REMARKS

Appln. No. 10/085,172
Amendment Dated 12/23/04
Reply to Office Action Dated 08/26/04
ANNOTATED SHEET SHOWING CHANGES

FIG. 6

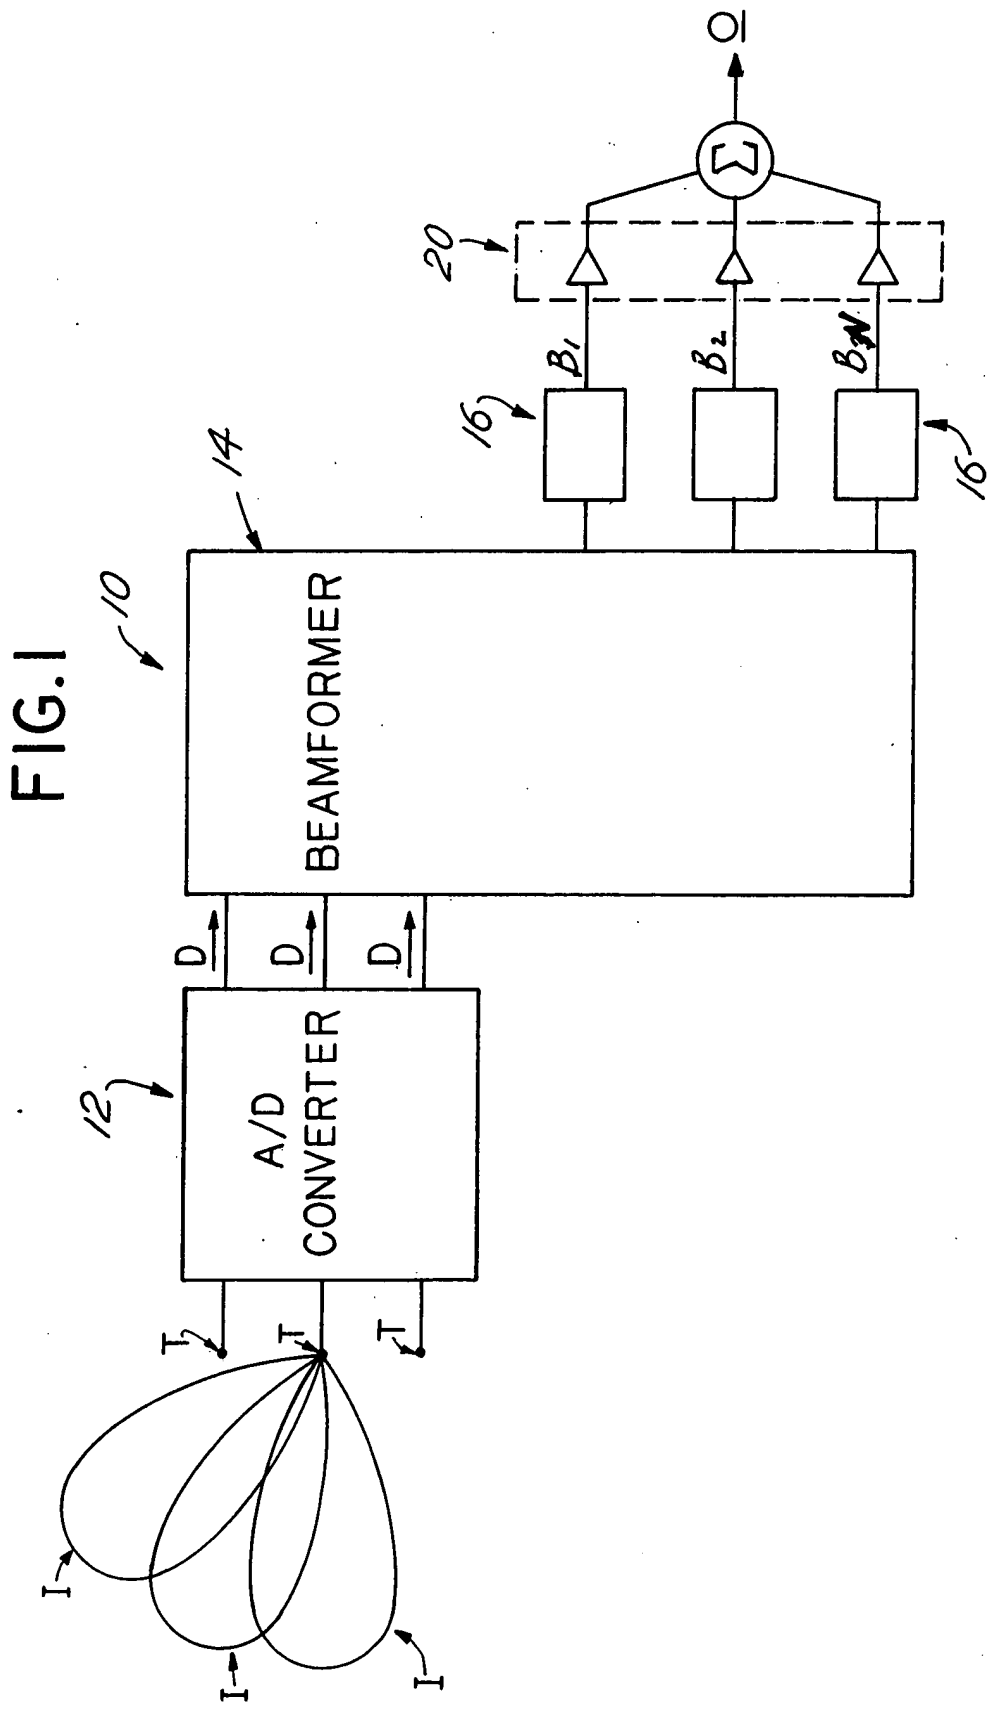
The Applicant is amending Sheet 4 and Sheet 5 (as attached to this paper) to interchange the labels “Fig. 6” and “Fig. 7”. As described in the Brief Description of the Drawings of the present patent application, as originally filed, Fig. 6 is a “polar plot of various frequencies signals **processed** by the present invention” and Fig. 7 is a “polar plot of various frequencies signals **unprocessed** by the present invention”. (Emphasis added.) As amended, Fig. 6 corresponds to the processed signals associated with the unprocessed signals as shown for Fig. 5, and Fig. 8 corresponds to the processed signals associated with the unprocessed signals as shown in Fig. 7. In accordance with the present invention, the beam of the processed signals is narrower than the beam of the unprocessed signals. For example, the present specification, as originally filed, discloses (Page 20, lines 2-8):

Interchanging the labels of Sheet 4 and Sheet 5 is necessary to maintain this relative beamwidth relationship between processed and unprocessed signals.

~~FIG. 7~~
